**CUMBERLAND CITY COUNCIL SUBMISSION
PLANNING PROPOSAL AT 1 CRESCENT STREET, HOLROYD (2017SWC141)**

CUMBERLAND CITY COUNCIL SUBMISSION PLANNING PROPOSAL FOR 1 CRESCENT STREET, HOLROYD (2017SWC141)

Traffic and Transport Technical Review on Planning Proposal for 1 Crescent Street, Holroyd

In response to the public exhibition
of a Planning Proposal at
1 Crescent Street, Holroyd

Intersection modelling

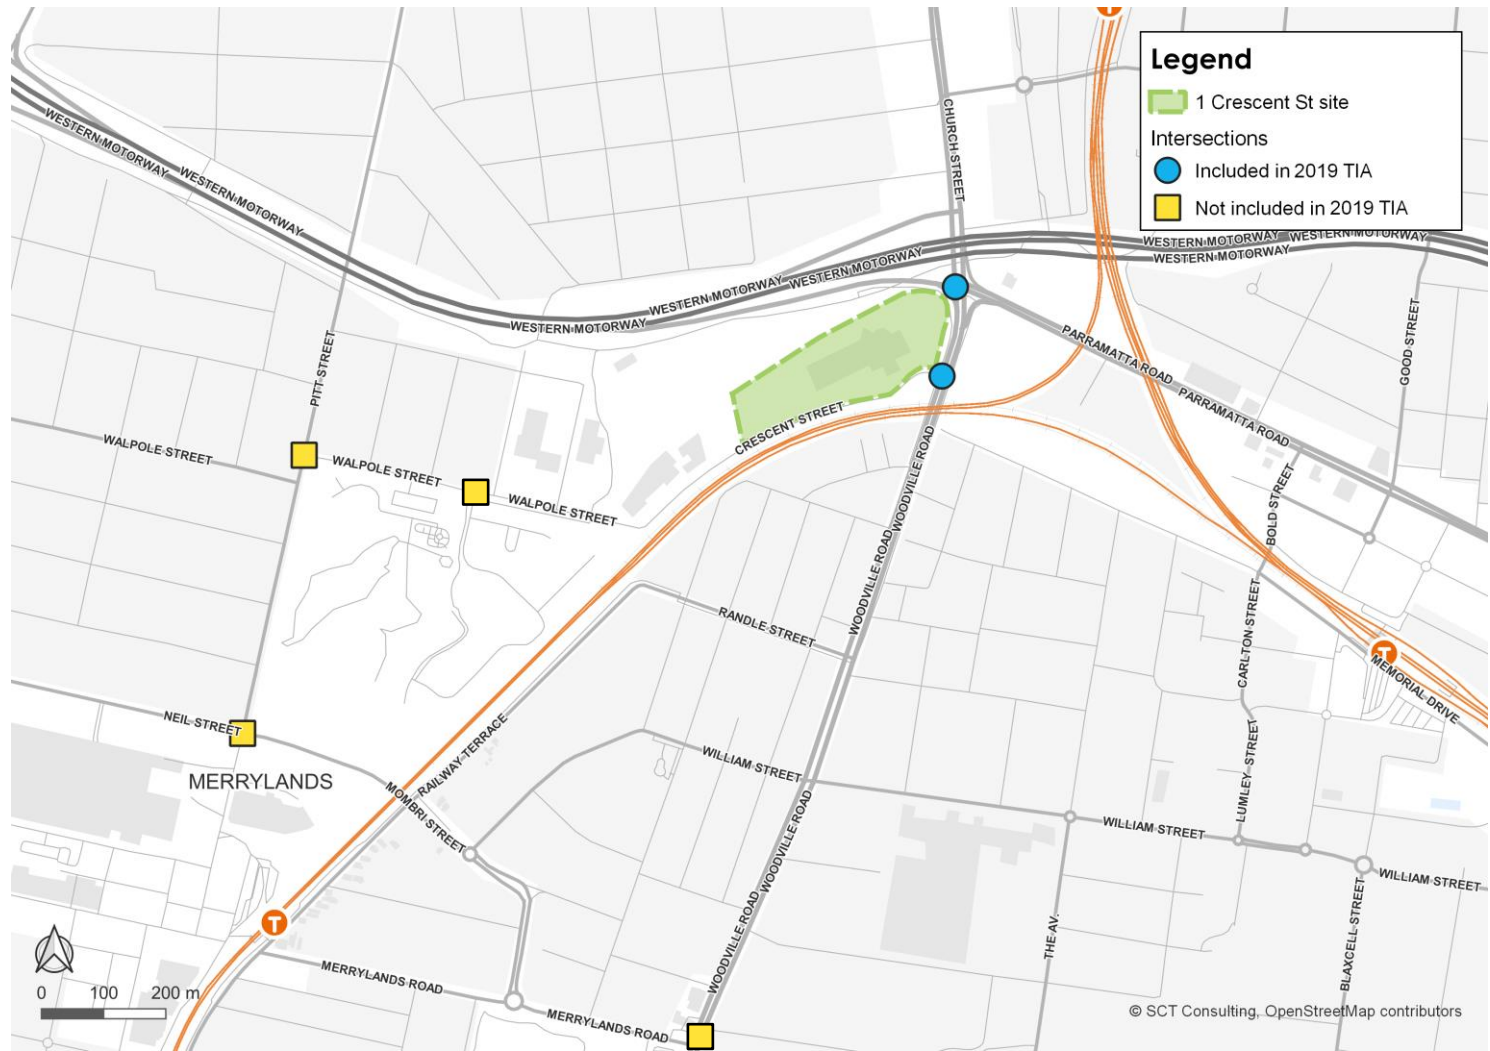
- Degree of Saturation (DoS) of future year flows is close to or above 1.0 for both intersections in the SIDRA analysis, even with the proposed upgrades by the applicant. An intersection should not exceed 1.0 in SIDRA analysis and suggests that these intersections are very near or have exceeded capacity.

- AM Parramatta Road / Woodville Road: 1.13 DoS
 - PM Parramatta Road / Woodville Road: 1.05 DoS
 - AM Woodville Road / Crescent Street: 1.04 DoS
 - PM Woodville Road / Crescent Street: 0.96 DoS

Woodville Road / Parramatta Road / Crescent Street – before

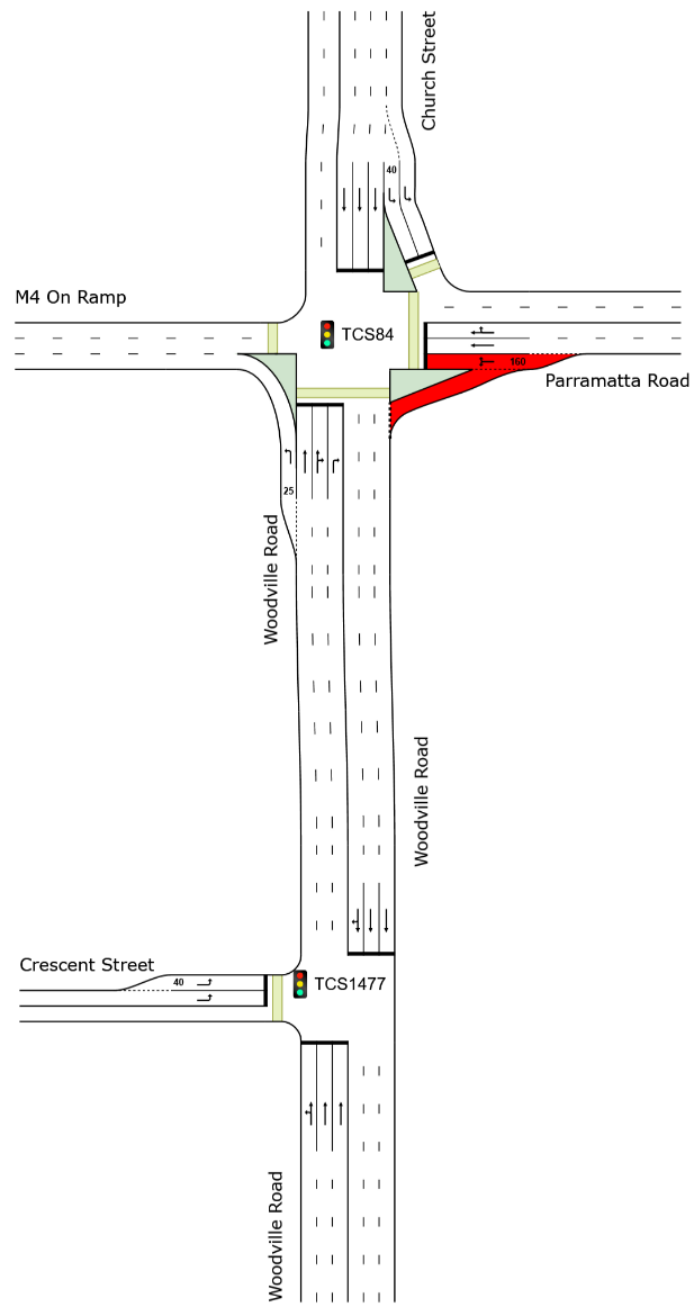
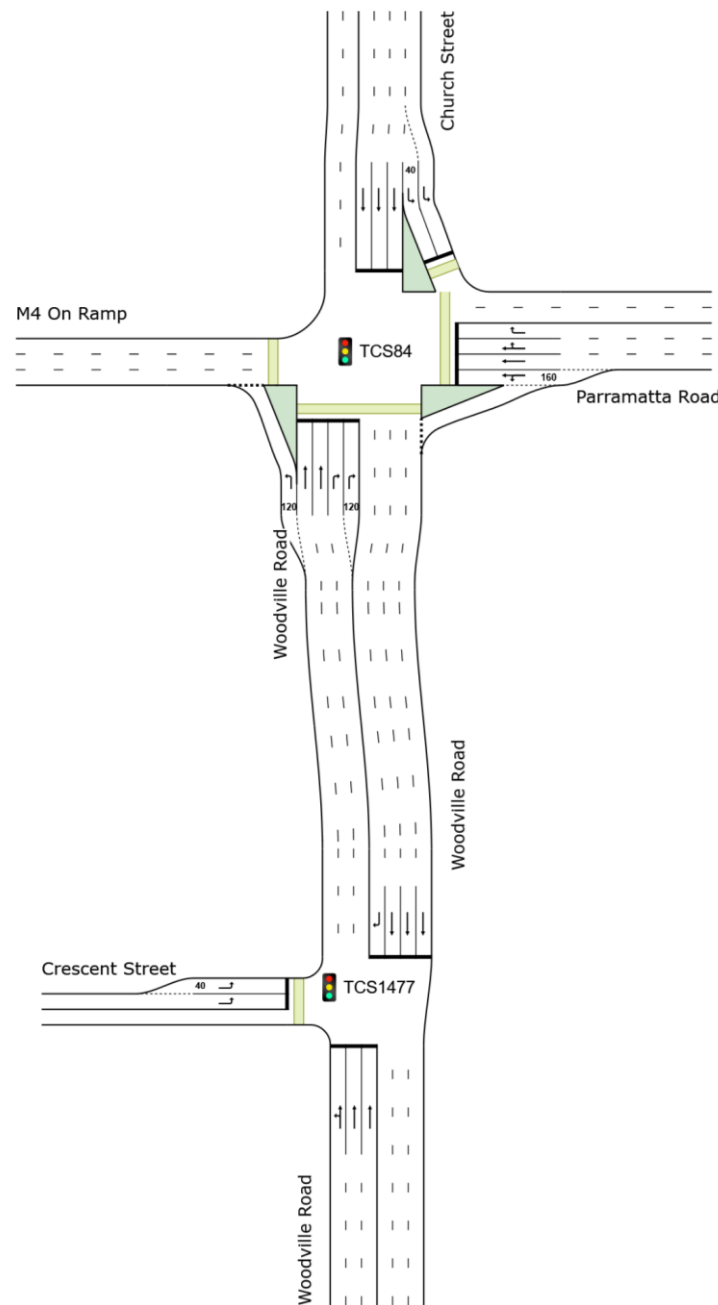
- The **Woodville Road / Parramatta Road** intersection currently sees significant delays. With TfNSW's committed upgrade, Levels of Service are forecast to improve, and remain acceptable (**LoS C**) even with the development traffic added.

Pitt Street / Neil Street – before

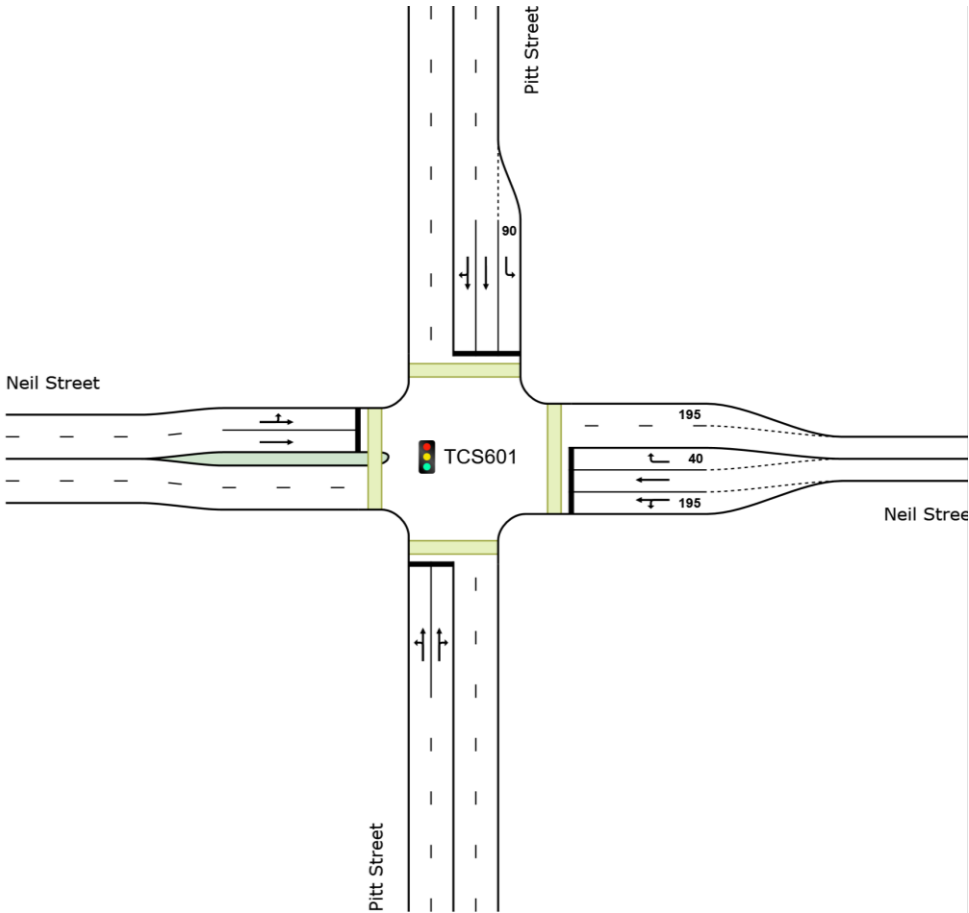
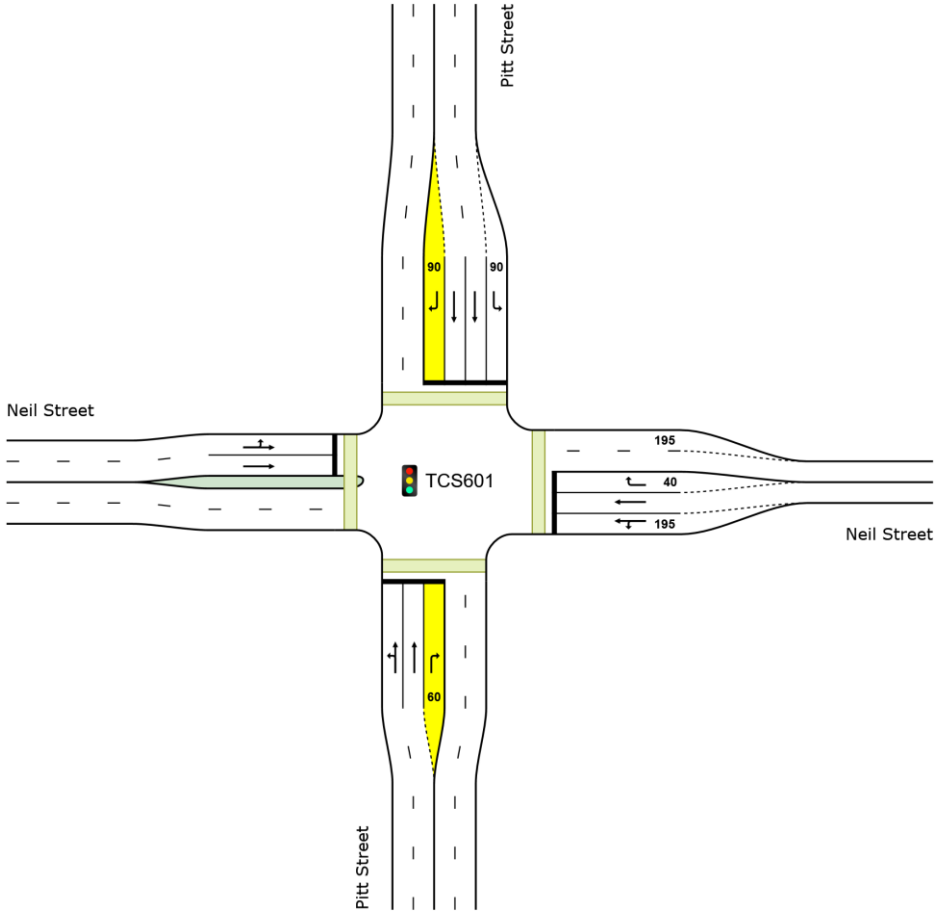
- Alternatively, the Pitt Street / Neil Street intersection could be relieved with a *Merrylands town centre bypass*. The idea of a bypass has been noted in previous studies (e.g. 2013 Holroyd Town Centres Transport Study), but it has never been modelled or designed in any detail to date. Further discussions with Council will need to be undertaken to investigate this.

Figure 3 – Comparison between recommended and proposed zoning controls

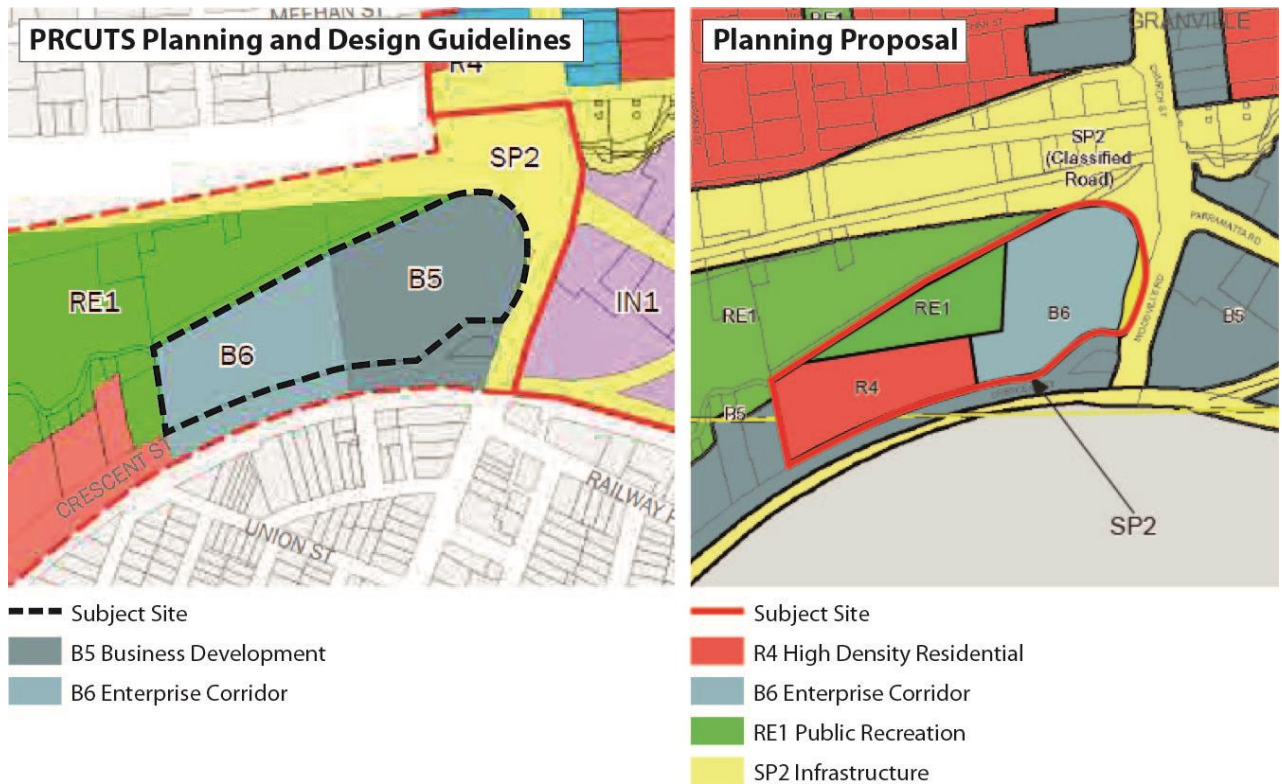
The proposed amendments to the HLEP 2013 under the planning proposal are significantly different from the recommended controls under the PRCUTS, as seen in **Figures 3, 4 and 5** below:

The proposed zoning amendments reduces both the existing and recommended employment generating zones with an excessive increase in residential uses for a site in this location. Furthermore, the proposed heights and densities (FSRs) under the planning proposal go above and beyond the PRCUTS' recommended controls. The proposed controls are largely inconsistent with what is envisioned for the site under the PRCUTS.

(4)(c) – as indicated above (refer to **Figures 3, 4 and 5**), the proposed controls under the planning proposal are significantly inconsistent with the recommended controls under the PRCUTS *Planning and Design Guidelines*.

Figure 6 – Granville Action Plan 2016-2023 from the PRCUTS *Implementation Plan 2016-2023*

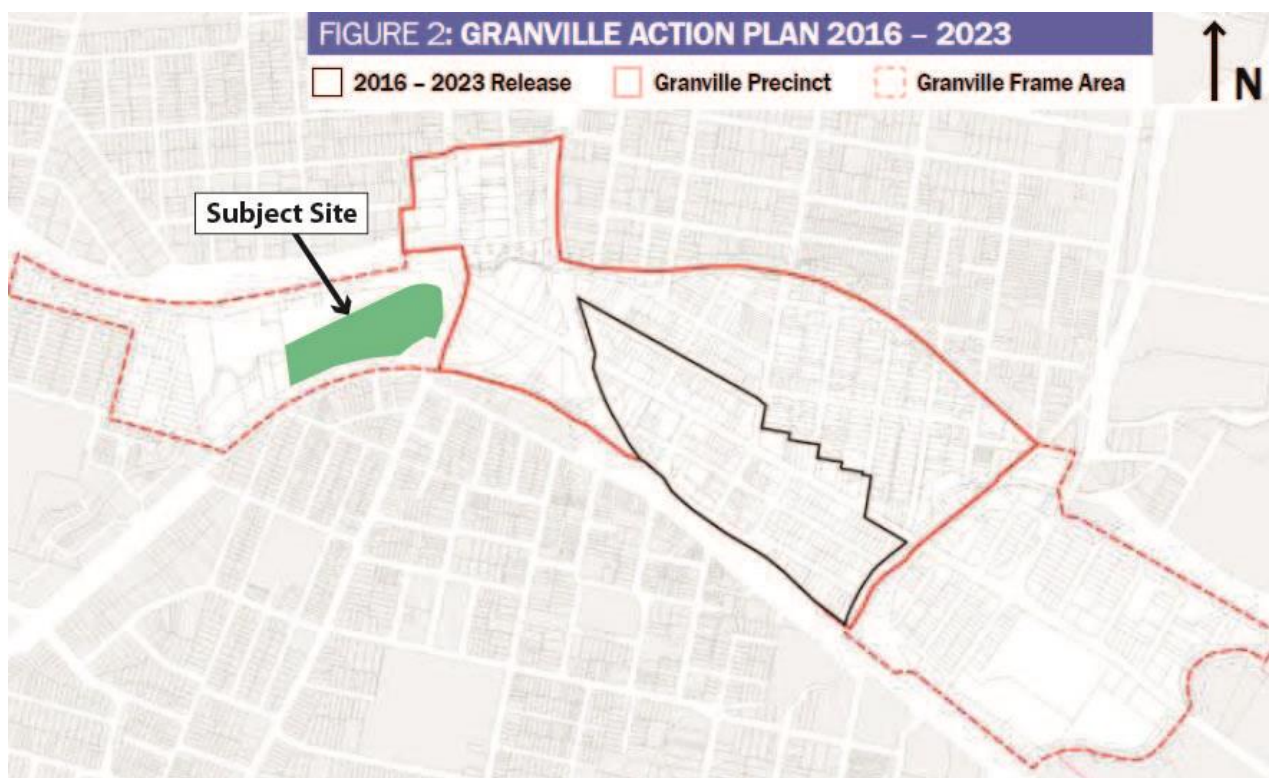
(4)(d) – the planning proposal is seeking a rezoning outside of the PRCUTS *Implementation Plan 2016-2023* action plan. According to the *Implementation Plan 2016-2023*, the subject site is outside of the release area for 2016-2023. The release area is only applicable to the core of the Granville Precinct which is bounded by Granville station to the south, the rail line to the west, Parramatta Road to the north and Duck Creek to the east (**Figure 6**). Accordingly, the planning proposal is inconsistent with the staging for land use change identified in the *Implementation Plan 2016-2023*.
